## Memorandum

To: Bassett Creek Watershed Management Commission (BCWMC)  
From: Barr Engineering Co.  
Subject: Item 5Aiii: Consider Approving 90% Design Plans for Four Seasons Mall Area Water Quality Improvement Project (2013 CIP NL-2) – Plymouth, MN  
BCWMC December 15, 2022 Meeting Agenda  
Date: December 8, 2022  
Project: 23270051.53 2022 623

### 5Aiii Consider Approving 90% Design Plans for Four Seasons Mall Area Water Quality Improvement Project (2013 CIP NL-2) – Plymouth, MN

### Proposed BMPs

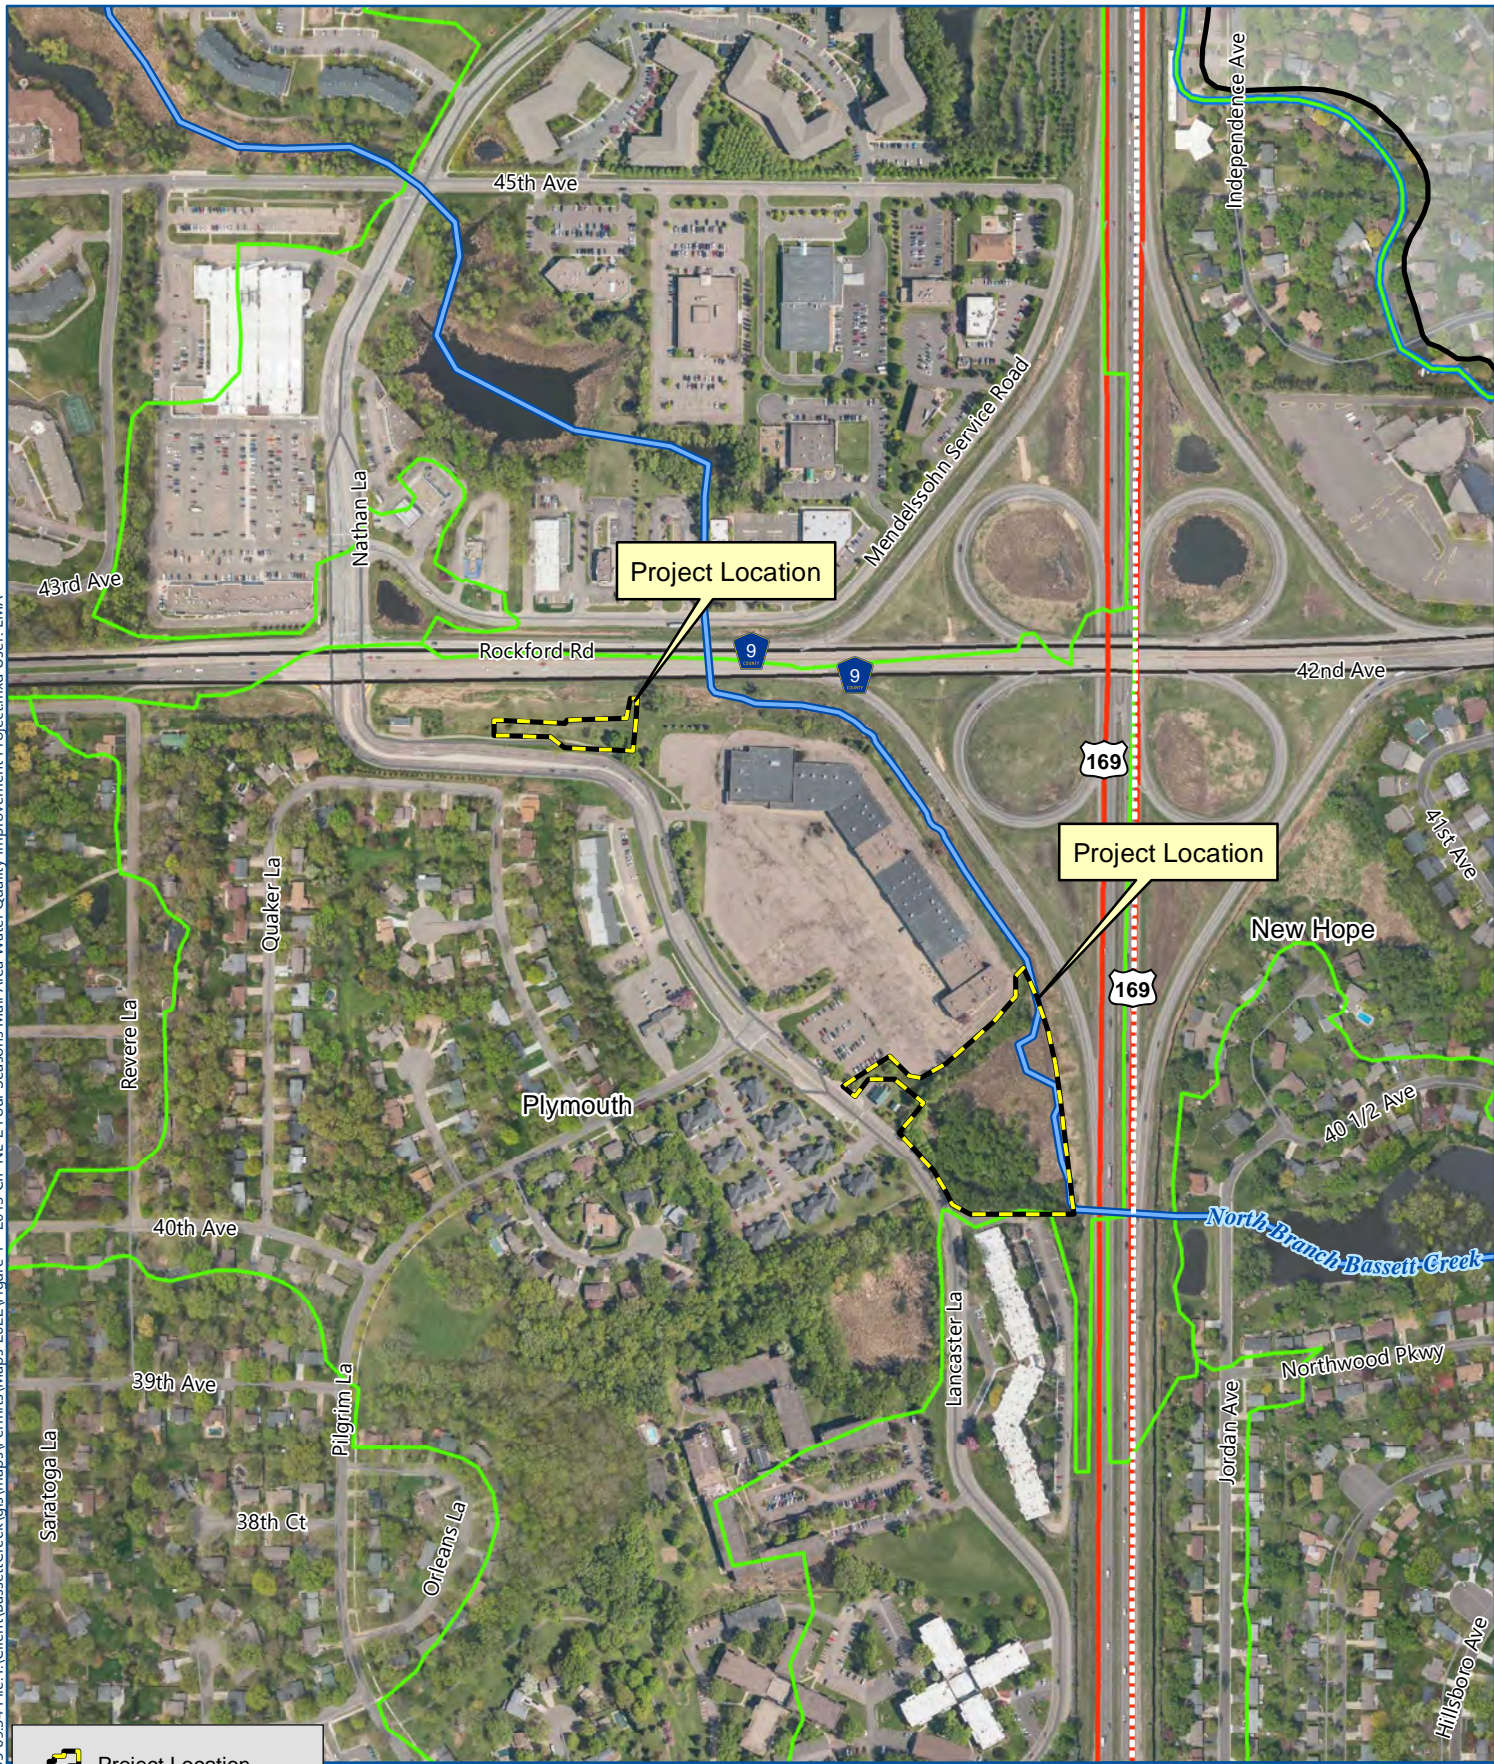
The proposed CIP best management practices (BMPs) on the Four Seasons Mall site will treat stormwater from the site and off-site areas with a small stormwater pond (Northwest Pond), vegetated swale, a large stormwater pond (South Pond) with a forebay, and a wetland restoration as shown in the Proposed BMPs figure provided by WSB. Table 1 summarizes the estimated annual TP loading to each proposed BMP and the TP removals provided by each proposed BMP on the site, not including the wetland restoration. The TP loading is based on the “existing conditions” impervious surface area of 11.93 acres (the amount of impervious surface on the Four Seasons Mall site before demolition).
